In Reply Please Refer to: 3174-F5A

January 6, 1993

2900 Ladd Avenue Livermore, California

ADDENDUM TO WORK PLAN

SITE PLAN WITH SAMPLING LOCATIONS L.V.J.U.S.D. MAINTENANCE YARD 2900 LADD AVENUE

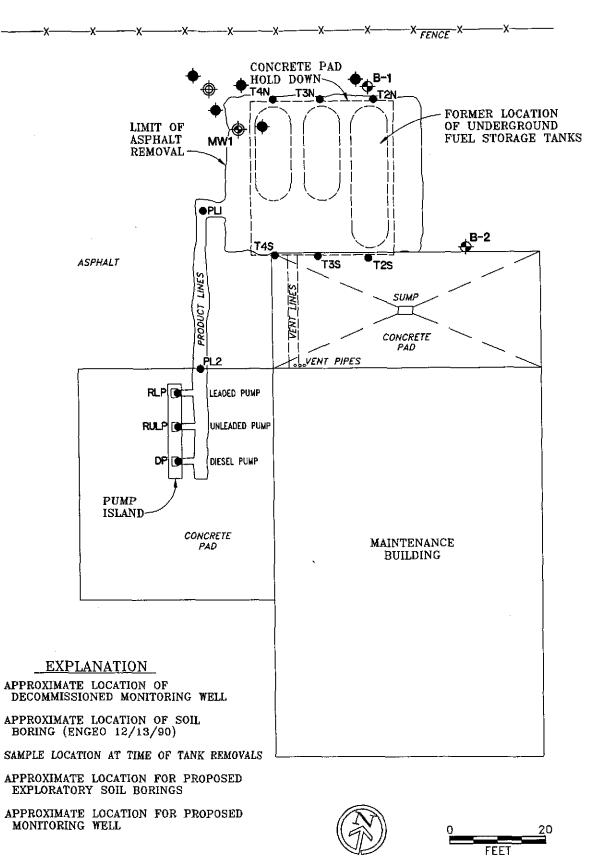
As requested in your December 15, 1992, letter to ENGEO, we have prepared this addendum to the referenced work plan to address the contamination at 2900 Ladd Avenue in Livermore, California. The revisions to the work plan will include the addition of two exploratory borings in the locations shown on Figure 1.

One of the added exploratory borings will be located in the backfill above the location of the former underground fuel storage tanks. Drilling in this area will require coring of the concrete slab which was left in place at the time of the removal of the underground tanks. A second added exploratory test boring will be drilled in the vicinity of the December 1990 boring B-1 (Figure 1).

The location of the proposed ground-water monitoring well is shown on Figure 1. This well will be constructed with four-inch-diameter PVC casing to facilitate possible remediation of contaminated ground water.
